GIF Task Force Response to IAEA's Comments on "GIF SFR Safety Design Criteria (SDC) Phase I Report"

Y. OKANO GIF SDC Task Force member

5th Joint IAEA-GIF Technical Meeting/Workshop on Safety of SFR, IAEA, 23-24 June, 2015

Criterion 20: Design extension conditions

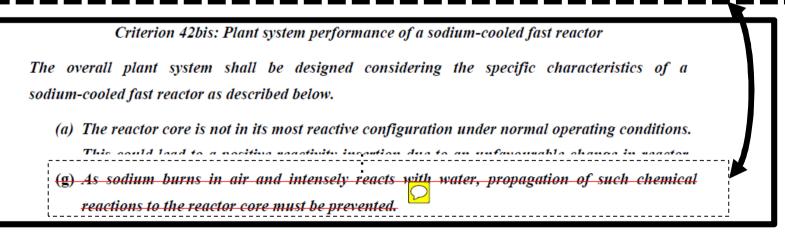
Add the underlined part: "The paragraph 5.32: ...Certain events might be consequences of other events, such as a flood following an earthquake <u>or a</u> <u>sodium fire following a steam generator tube rupture</u>...;"

The example in the original text is a combination with "inevitable subsequence", such as tsunami by earthquake. Here "inevitable" means that it cannot be mitigated by "design". The IAEA proposal to add "sodium fire after SG tube rupture" is in different situation in which the SG tube rupture is mitigated by various "design" measures. The proposal is not adequate to be added.
